## Road Safety Audit Review

<b>Town:</b>	Berkshire	<b>Date Reviewed:</b>	September 11, 2015
<b>Route:</b>	VT 118, Richford Rd and Water Tower Rd	<b>Mile points:</b>	S0302: 2.65 S0307: 4.10

The location of this RSAR is the intersection of Berkshire Center Road, Richford Road and Water Tower Road in Berkshire.

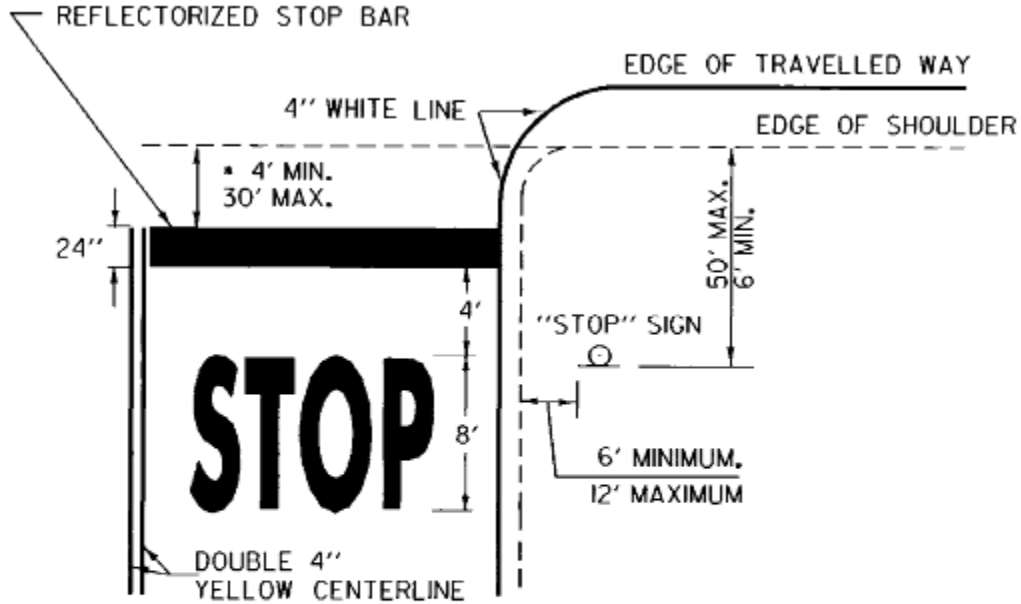
Concern: Corner Sight Distance Issue, Northwest Quadrant

The corner sight distance when stopped on Water Tower Road and looking to the left (north) is poor (*measured at 384 feet, which is below the required 555 feet value for the 50 mph posted speed limit*). The presence of brush/trees contributes to this issue.

Ensure that the stop bar is located four feet from the edge of the road to maximize corner sight distance and that it is visible and refreshed on a yearly basis as needed (see the detail below).

Provide a clear sight triangle by removing any obstructions that are located inside the boundaries of the triangle.

Note, Intersection Sight Distance (ISD) for 35 mph is 390 ft, for 40 mph, 445 feet and 555 ft for 50 mph as per AAHSTO.

Add an advisory plaque to the northbound advance warning intersection assembly that would match the speed for the corresponding available corner sight distance (35 mph plaque).
